MIL-C-55693(EL)
AMENDMENT 3
27 January 1976
SUPERSEDING
AMENDMENT 2
2 AUGUST 1973

MILITARY SPECIFICATION

COUPLERS, ANTENNA CU-942( )/AR, CU-1894( )/AR
AND ANTENNA AS-1703( )/AR

This amendment forms a part of Military Specification MIL-C-55693(EL), dated 3 February 1970, and is approved for use by all departments and agencies of the Department of Defense.

Figure 1

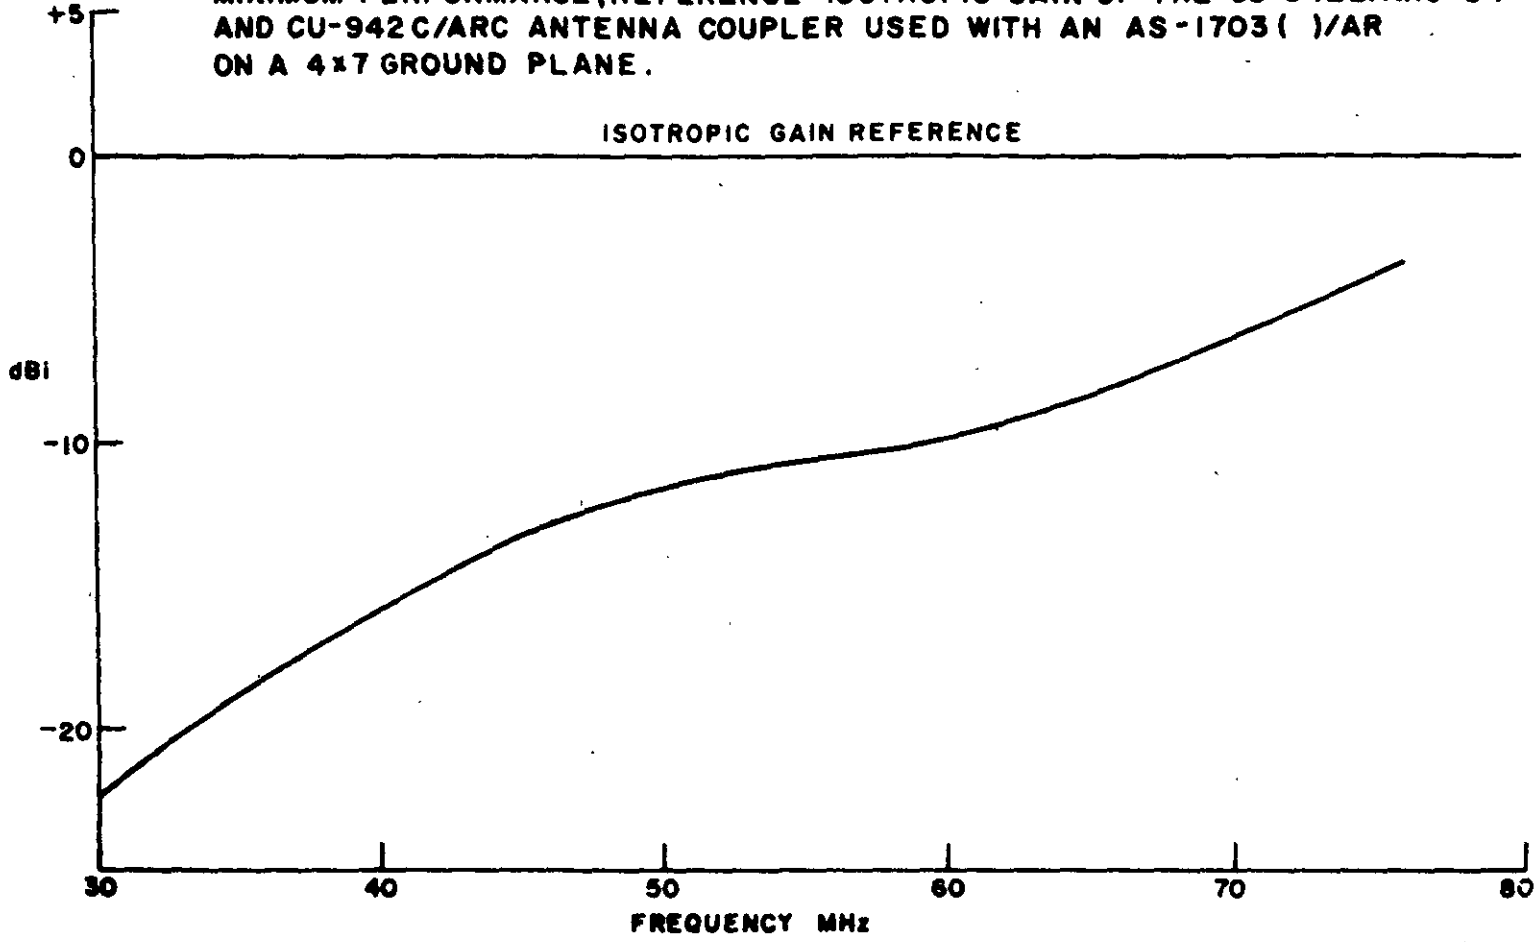
3.12.4: Add the following:

"3.13.4 Gain (See 4.10.4). - The minimum performance, reference isotropic gain, of the Antenna Coupler(s) as used with the AS-1703 Whip Antenna shall be as shown on Figure 1."

"6.2.e Submission of Gain Measurement Procedure referenced in 4.10.4 should be as specified in the Solicitation/Contract unless otherwise specified. This procedure should be submitted to the Contracting Officer." Add figure 1 shown on page 7 of this amendment.
